CWMs IN IEEE 25GE (802.3by)

Eric Baden

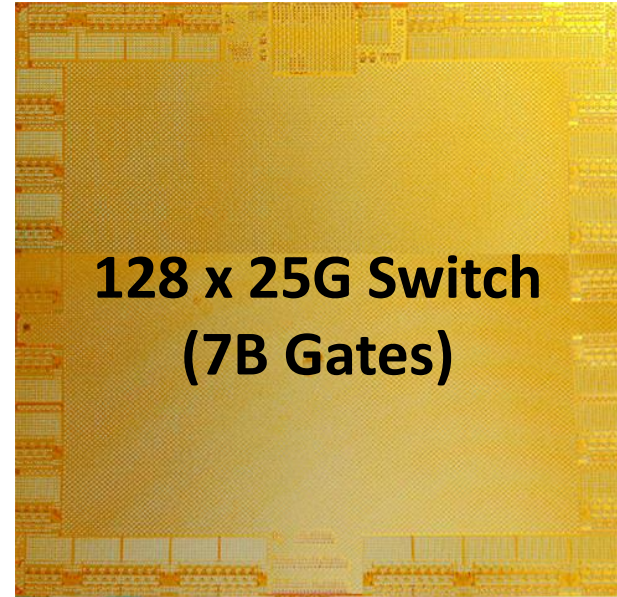
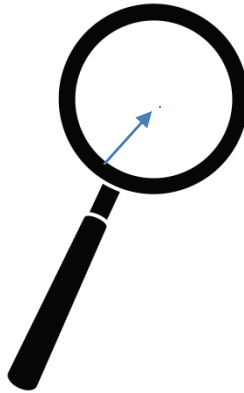
- *WRT “Matches method used by another standard [Fibre Channel] which already defines single lane RS-FEC solution (designs supporting both just rate scale)”*
 1. This was never a part of our Broad Market Potential or Economic feasibility justification.
 2. IEEE AN mechanism and bit rates, training, data rates, and FEC selection are incompatible with FC.
 1. For instance, FC AN requires the SERDES to transmit at one rate and receive at a completely different rate.
- **CONCLUSION: Compatibility with Fibre Channel is not achieved and is not relevant.**
